JANUARY 2020

PL6

NON MATERIAL
AMENDMENT
PLANNING
APPLICATION
& CONDITION 4
DISCHARGE

44 A GLOUCESTER
AVENUE LONDON
NW1 8JD

4.1 CHANGES TO CONDITION 4 FRONT ELEVATION

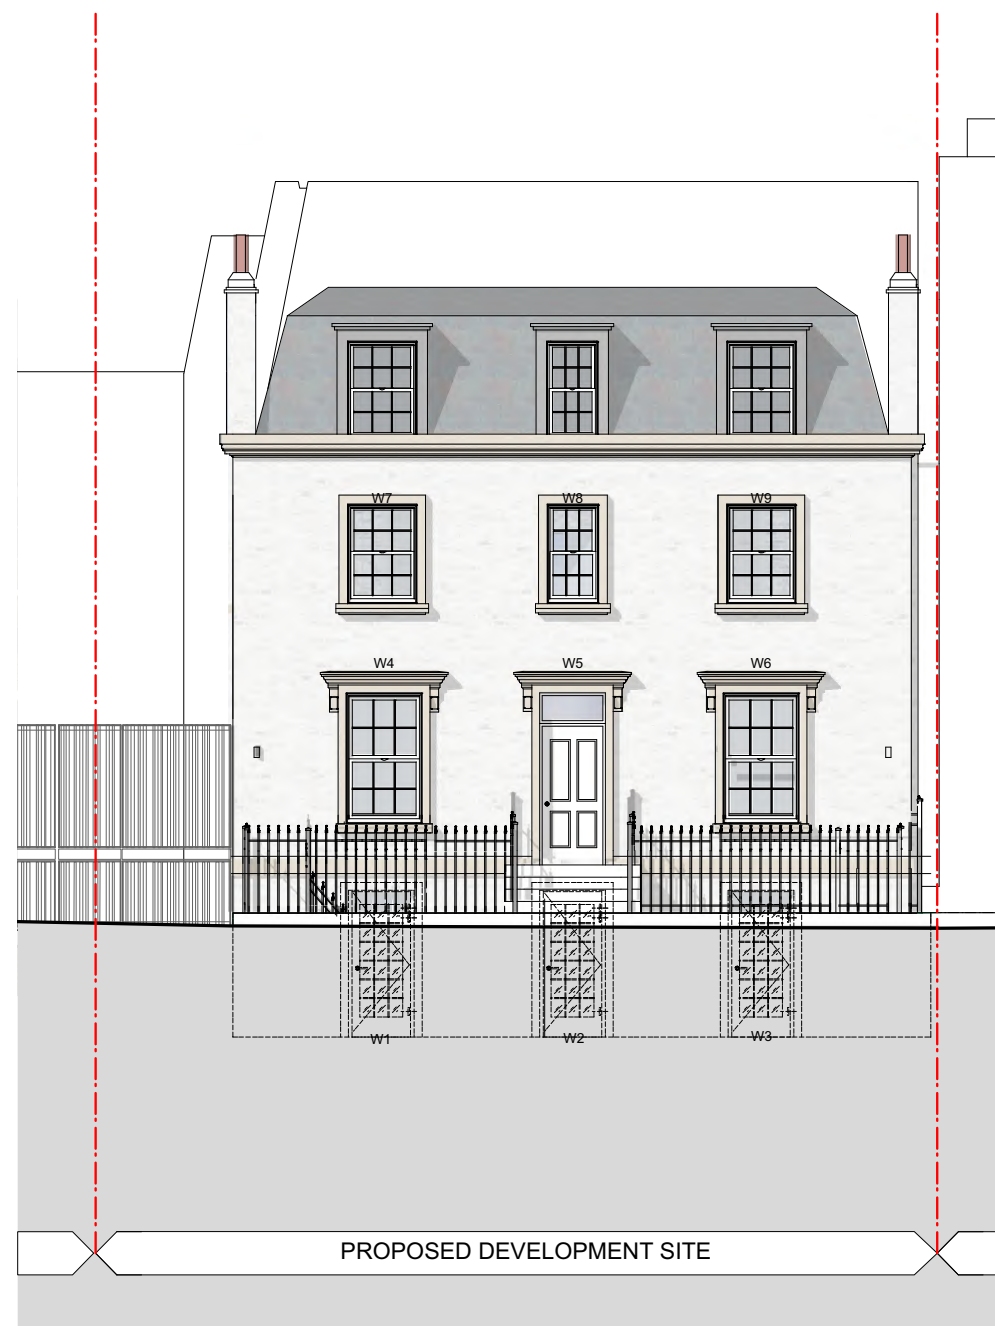
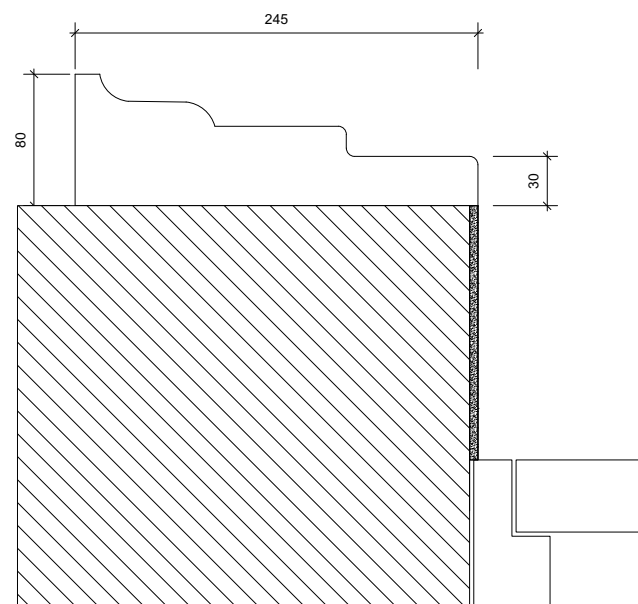
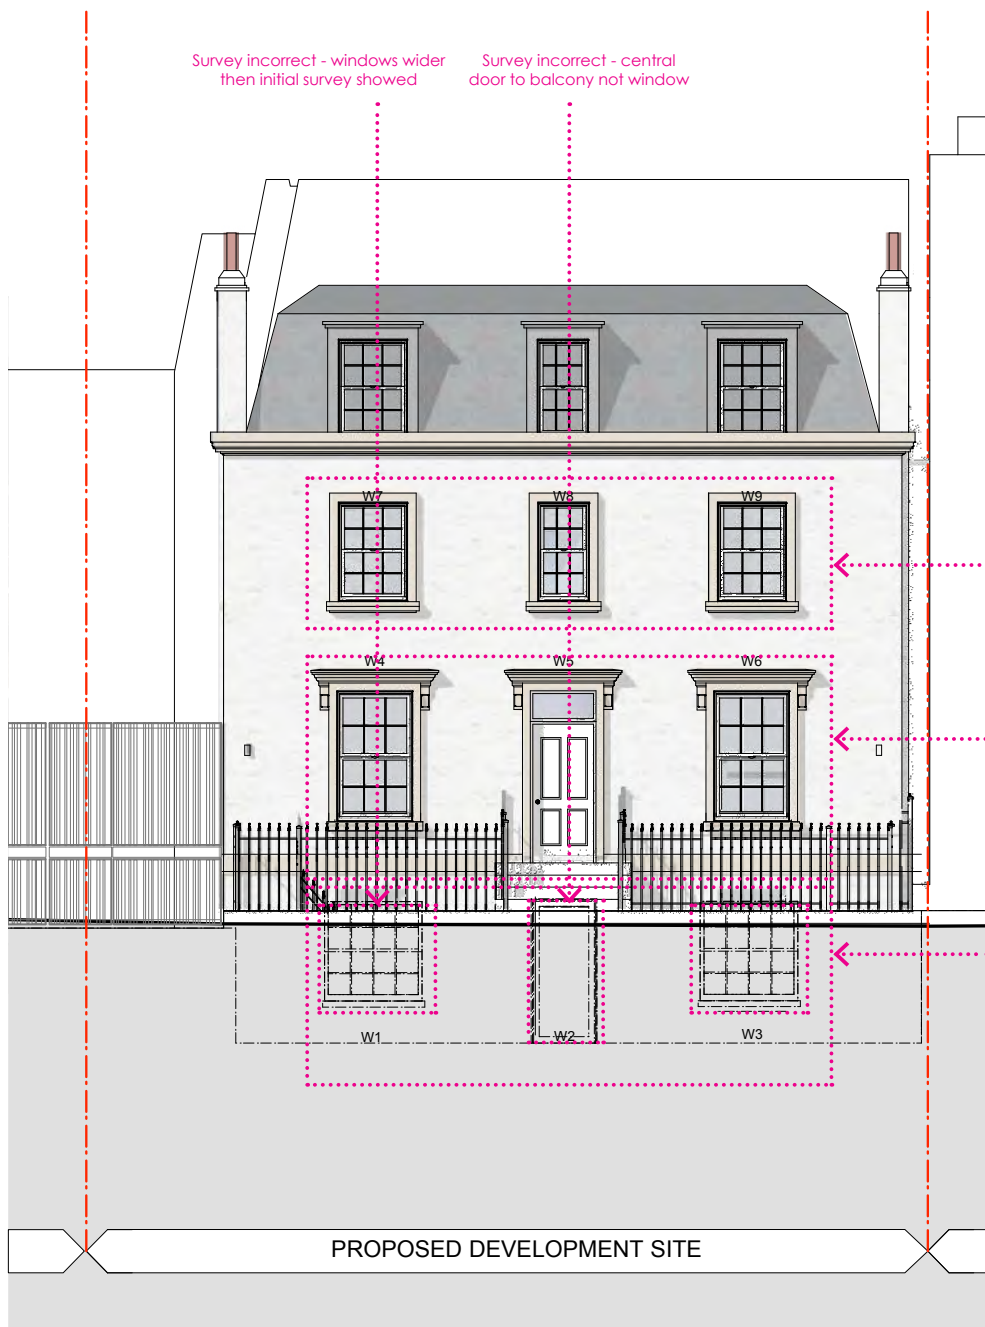
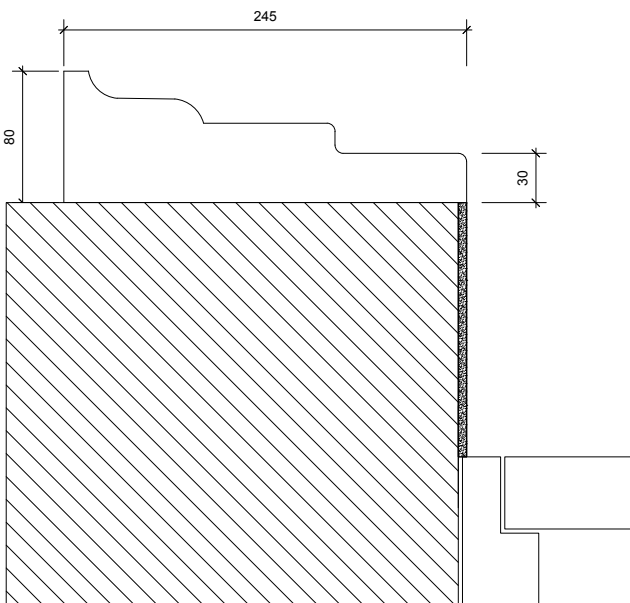
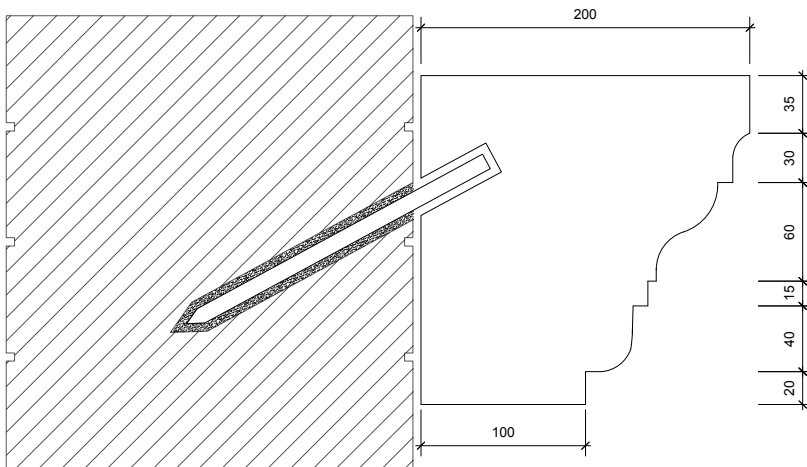
BASEMENT WINDOWS (W1 and W3)
Existing Cill to be removed, as they have significant cracks, with a new stone cill formed with upstand to receive window.
Profile to be added to the frame on three sides oversailing the existing base to the reveal.

BASEMENT DOOR (W2)
Existing concrete plinth to be clad over with a new stone cill.
Profile to be added to the frame on three sides oversailing the existing base to the reveal.

GROUND FLOOR WINDOWS (W4 and W6)
Existing Cill to be removed, as they have significant cracks, with a new stone cill formed with upstand to receive window.
Profile to be added to the frame on three sides oversailing the existing base to the reveal.
The rolls and entablatures to be fixed through the wall beyond the frame.

ENTRANCE DOOR (W5)
Existing concrete plinth to be clad over with a new stone cill.
Profile to be added to the frame on three sides oversailing the existing base to the reveal.
The rolls and entablatures to be fixed through the wall beyond the frame.

FIRST FLOOR WINDOWS (W7 - W9)
Existing Cill to be removed, as they have significant cracks, with a new stone cill formed with upstand to receive window.
Profile to be added to the frame on three sides oversailing the existing base to the reveal.

Consented documents
discharging condition 4 have
been approved considering
window cills and the surrounds for
the windows to be Yorkstone.
New proposal includes stone to
be **Portland stone** to match the
original design

4.2 CHANGES TO CONDITION 4 SIDE ELEVATION

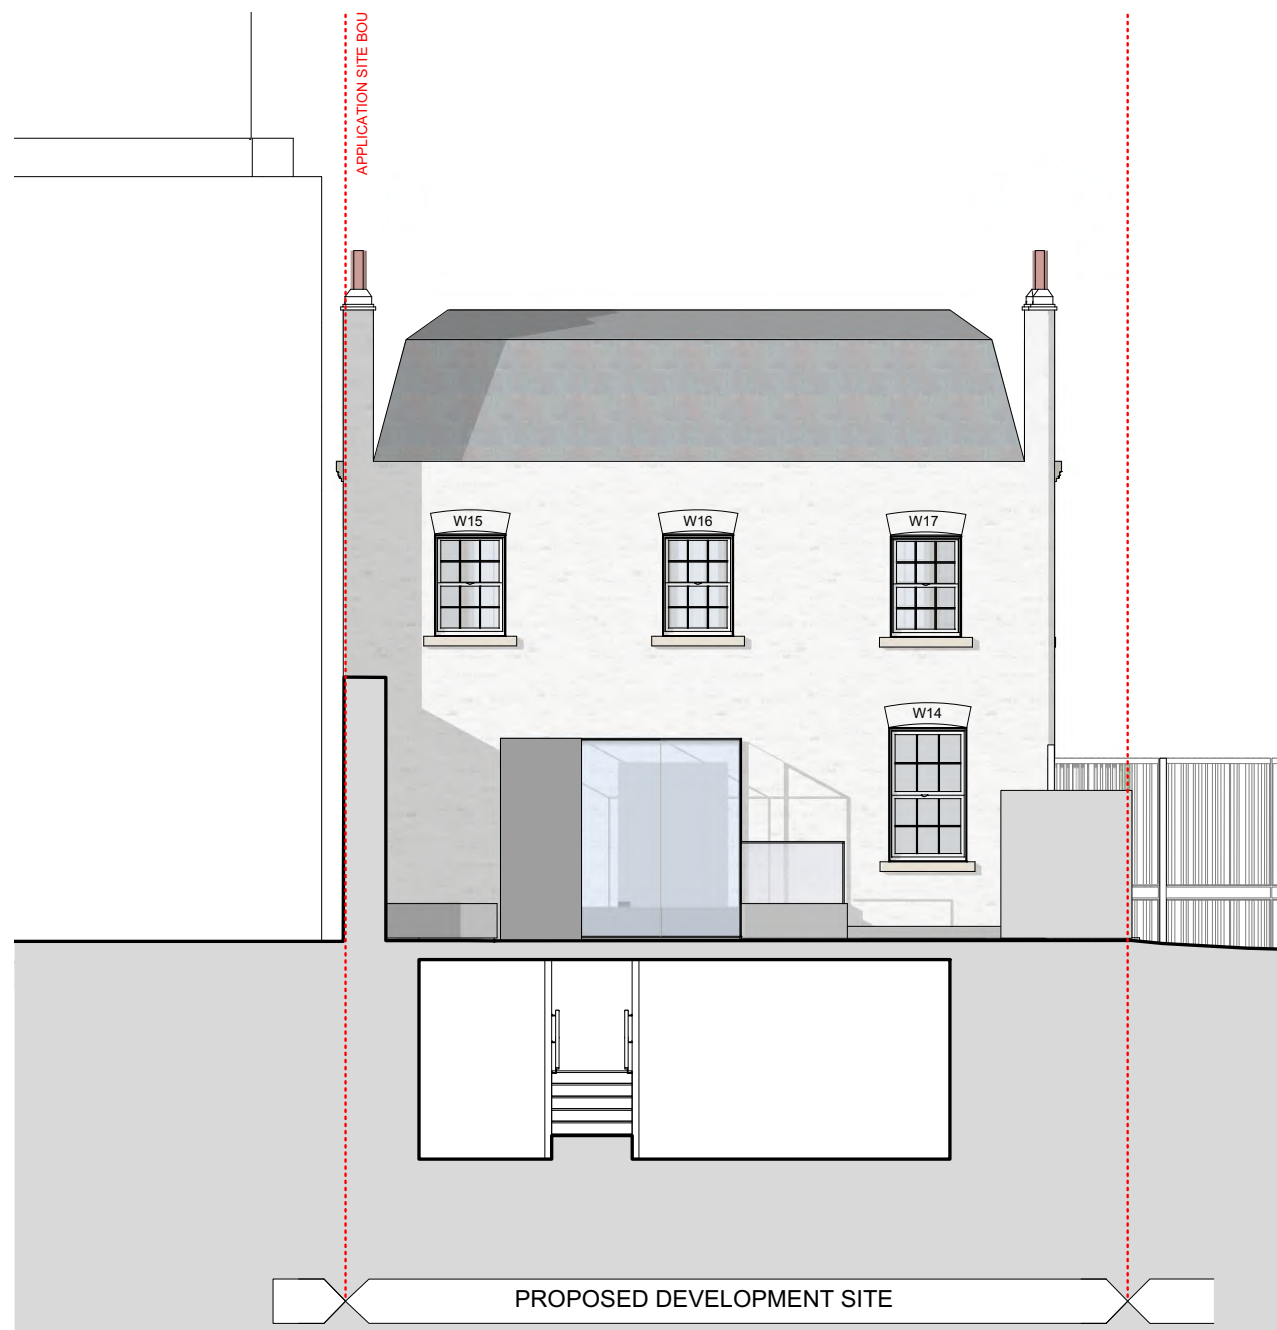
GABLE ELEVATION WINDOWS and Door (W10 - W13)
New cills to be provided as there are not enough existing cill which can be salvaged and re-used.

Consented documents discharging condition 4 have been approved considering window cills and the surrounds for the windows to be Yorkstone. New proposal includes stone to be **Portland stone** to match the original design
